Regulation No. 125 (Forward field of vision of drivers)

Proposal for amendments to Regulation No. 125

Submitted by the expert from Japan *

Figure 1

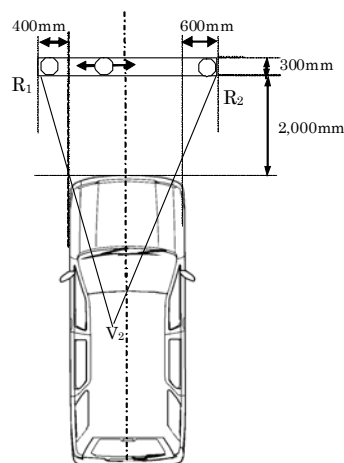
Insert a new paragraph 5.1.4., including new figures 1 and 2, to read:

"5.1.4. In the case where the height of V2 above the ground exceeds 1,650 mm, the following requirement shall be met:

A 1,200 mm tall cylindrical object with a diameter of 300 mm that is situated inside the space bounded by a vertical plane located 2,000 mm in front of the vehicle, a vertical plane located 2,300 mm in front of the vehicle, a vertical plane located 400 mm from the driver's side of the vehicle, and a vertical plane located 600 mm from the opposite side of the vehicle shall be at least partially visible when viewed directly from V2 (see figure 1), regardless of where the object is within that space, unless it is invisible due to a blind spot(s) created by the A pillars, windscreen wipers, or steering wheel.

Figure 2

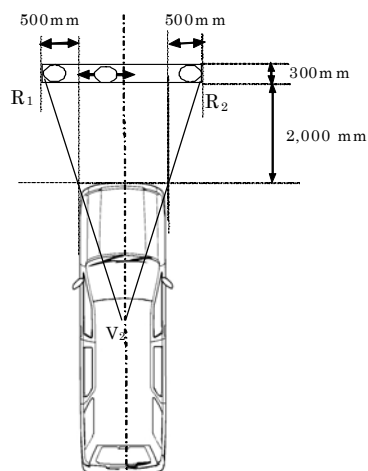
If the driver's seat is located in the central driving position of the vehicle, the 1,200 mm tall cylindrical object shall be situated inside the space bounded by a vertical plane located 2,000 mm in front of the vehicle, a vertical plane located 2,300 mm in front of the vehicle, a vertical plane located 500 mm from the side of the vehicle (see figure 2).
